## Product Change Notification

### PCN 2015-08-2060-2

#### **SMD PCB terminal blocks 2060 series.**

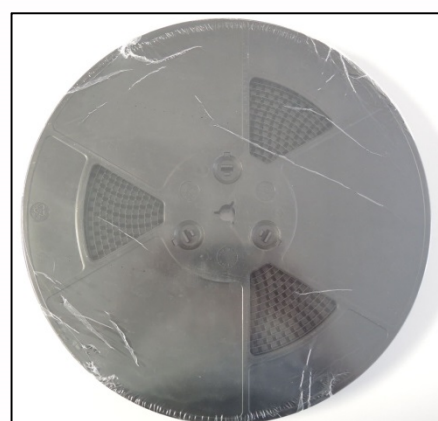
The packaging of SMD PCB terminal blocks 2060 series will be changed from PE foil bags to LDPE shrink wrapping.

The change will have no negative influence on moisture transition into the packaging.  
MSL-Level of WAGO SMD PCB terminal blocks is 1 ( Unlimited "Floor Life" at 30°C / 85% r.H.).

WAGO SMD PCB terminal blocks are not electrostatic discharge sensitive (ESD) devices.  
Nevertheless the shrink wrapping material is categorized as static dissipative acc. to EN 61340-5-3.
